From: Manoj Nathoo (AT)
Sent: Wednesday, 30 April 2025 9:38 am
To: Siobhan O'Donovan (AT)
Subject: FW: Canada/East St sketch

From: Putri Kusumawardhani (AT) <Putri.Kusumawardhani@at.govt.nz>
Sent: Monday, 10 March 2025 10:12 am
To: Sophia Wang (AT) <Sophia.Wang@at.govt.nz>; Vaughn Scott (AT) <Vaughn.Scott@at.govt.nz>; Mathew Rudez (AT) <Mathew.Rudez@at.govt.nz>
Cc: Manoj Nathoo (AT) <Manoj.Nathoo@at.govt.nz>; Jason Budd (AT) <Jason.Budd@at.govt.nz>; Suresh Patel (AT) <Suresh.Patel@at.govt.nz>; s7(2)(a) Privacy
<s7(2)(a) Privacy@beca.com>
Subject: RE: Canada/East St sketch

Subject: Canada/East St sketch

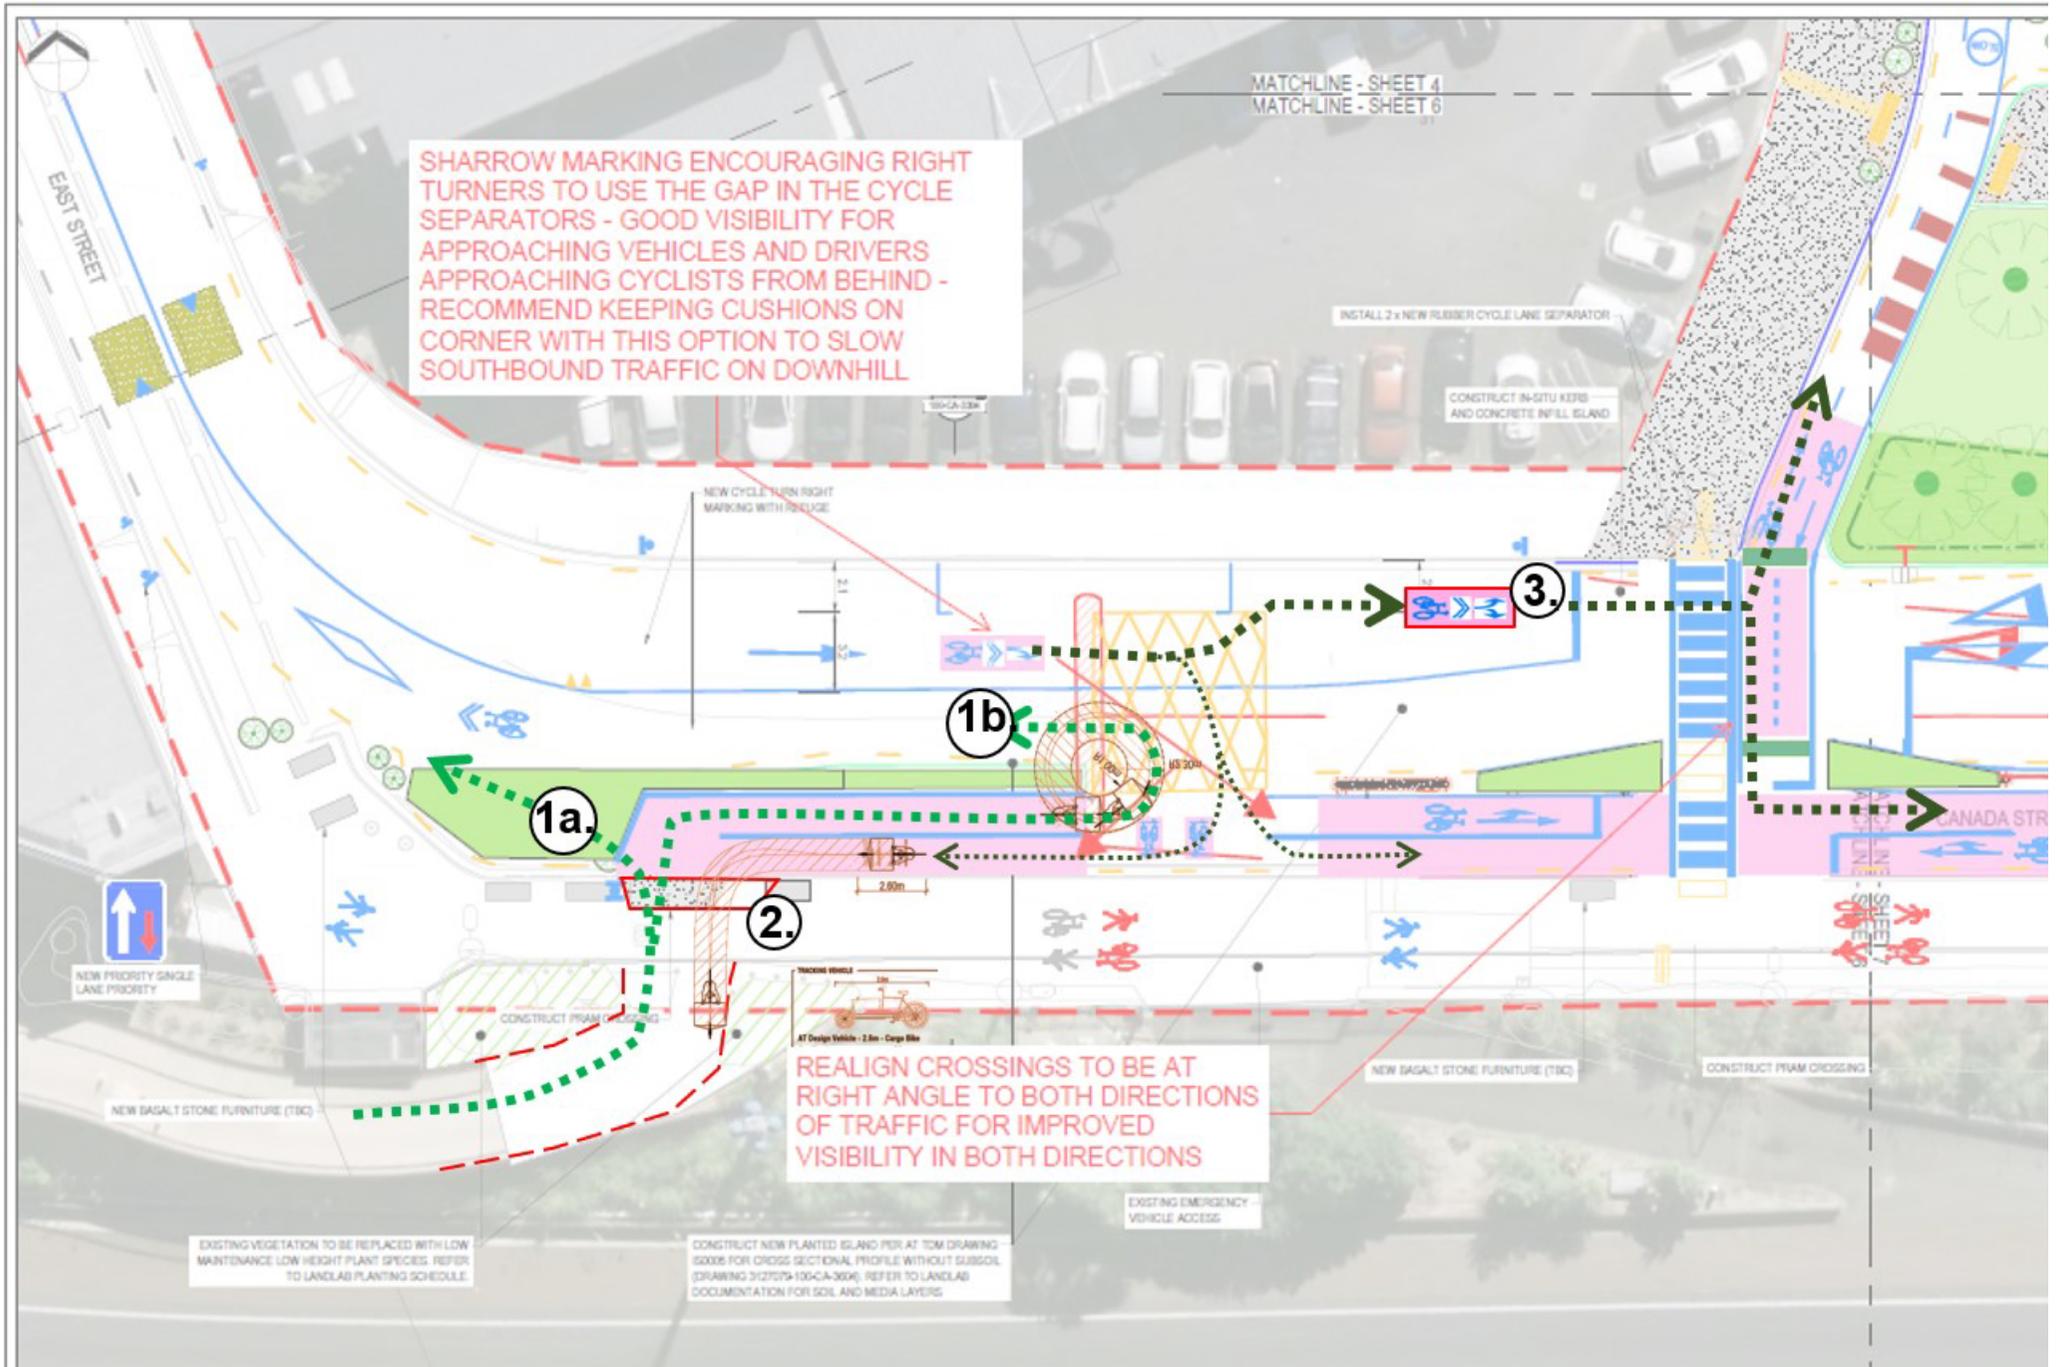
Apologies for the delay in my response. I've given a lot of thought to the expected movement concerning the updated design layout on Canada St/East St. From my technical perspective, I think **Option 1** is clearer. However, I believe there is a slight refinement needed specifically regarding radius turning, for Option 1.

1. People on bikes coming out from Lightpath should be able to turning left (1a.) rather than being expected to come out between the separator gap (intended for maintenance access). The turning manoeuvre (1b.) as currently designed seems quite challenging. Please see the tracking example attached for a clearer illustration.
2. Cycle ramp connecting Light Path to proposed (separated) cycleway will need to be widen and the proposed bench will need to be shifted outside the turning manoeuvre. Additionally, the cycle ramp should have a gentle gradient to assist the turning movement for cyclists. This will make the transition smoother and safer.
3. Additional sharrow marking with arrow is needed at the termination point of the sharrow to the separated cycleway to guide cyclists effectively.
